RE: Concept Site Plan Application SP-8415-2020 (10 and 14 East Deer Park Drive): DeVol Funeral Home ("Crematorium")

RE: DeVol Crematorium: SP-8415-2020 (10 and 14 East Deer Park Drive)

RE: Concept Site Plan Application SP-8415-2020 (10 and 14 East Deer Park Drive)
DeVol Funeral Home (“Crematorium”): Corrected Exhibit Number underlined below

Exhibit 2: Proposed crematorium with 25-Foot Stack

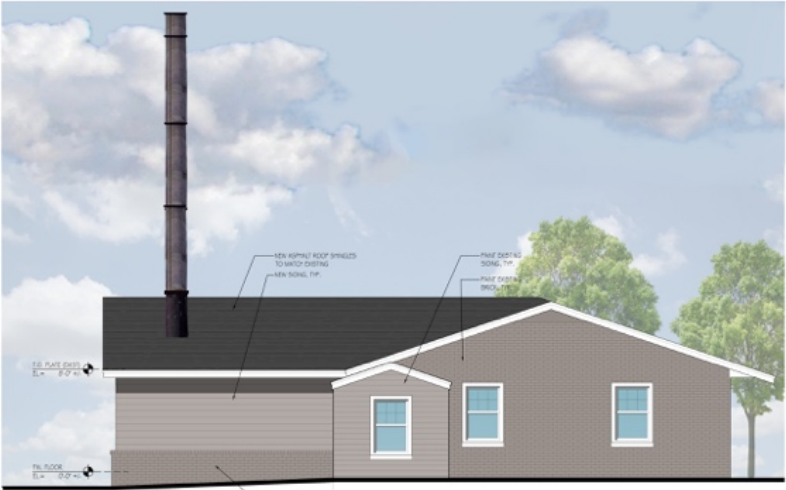
The latest Concept Plan drawings show an 8-foot “stack” height. See SP Exhibit No. 264.

The images below show a scaled rendering of the proposed crematory building with a 25-foot stack. Note: a 28-foot tall stack would not fit within the exhibit frame.

As is readily apparent from these images, the stack towers above the existing skyline, and will in no way be screened by the proposed landscape plantings shown on Exhibit 264 (which, according to statements made on behalf of the applicant at the September 9 community meeting, are shown at taller heights than they will be at the time of planting).¹

Accordingly, the proposal does not satisfy the standard set forth in City Zoning Code Section 24-160G.7(4), which requires that in order for the Council to approve the proposed crematorium it must find, among other things, that “The plan will be internally and externally compatible and harmonious with existing and planned land uses in the CD zoned area and adjacent areas.”

The surrounding area consists of single-family homes, a school, a park, and multi-family affordable residential housing. The industrial nature of a stack this tall (even if clad in brick or an alternative architectural treatment) is incompatible and not harmonious with the CD zoned area and adjacent areas, and the application must be denied on these grounds.
